Our Reference: SYD15/01307/04 (A14968375) Council Ref: DA 47/2016

## PROPOSED DEMOLITION AND CONSTRUCTION OF A FOUR LEVEL CHILD CARE CENTRE FOR 216 CHILDREN WITH ROOFTOP PLAY AREA AND 44 PARKING SPACES AT 239 PITTWATER ROAD, MANLY

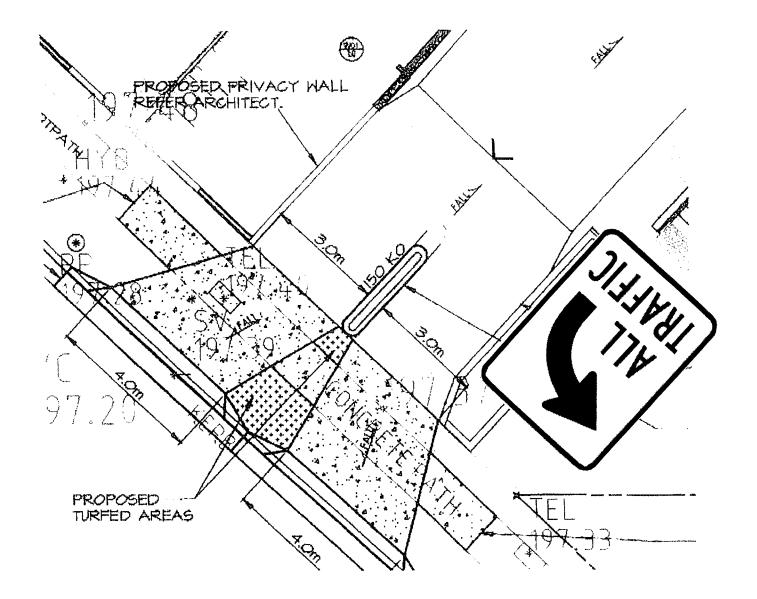
1. All vehicular access to the subject development shall be restricted to left in/left out (LILO) movements on road safety and network efficiency grounds. In this regard, a triangular raised median should be constructed at the driveway (within the property boundary) and the driveway splayed/angled to physically prevent vehicles turning right to/from the development.

A typical driveway design plan for LILO movements has been attached for your reference. An "All Traffic Left" sign is to be installed within the property boundary at the driveway (facing motorists exiting the site) as part of the development to enforce vehicles to exit the site in left turn only.
